ADDENDUM NO. 1
Kansas City Area Transportation Authority
1350 E. 17th Street
Kansas City, Missouri 64108

INVITATION FOR BIDS (IFB) #17-5036-33
BI-FUEL SHUTTLE BUSES FOR PARATRANSIT SERVICES

ADDENDUM NO. 3
Kansas City Area Transportation Authority
1350 E. 17th Street
Kansas City, Missouri 64108

Invitation for Bids (IFB) #17-5036-33
Bi-Fuel Shuttle Buses for Paratransit Services

Page 5, Section D 1a Line 11 Passenger Counter

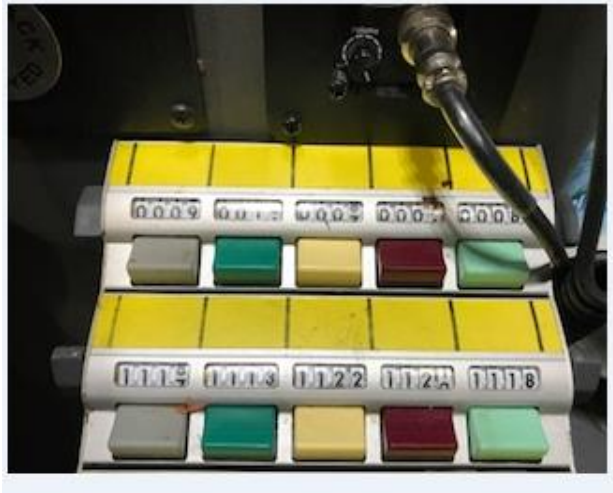
Question:

Please clarify what is required for the "Passenger Counter" as these can be very simple to very complex and automated.

See attached picture. Passenger counter should not be mounted. We're requesting that passenger counter arrive loose and will be mounted by us. (see picture)
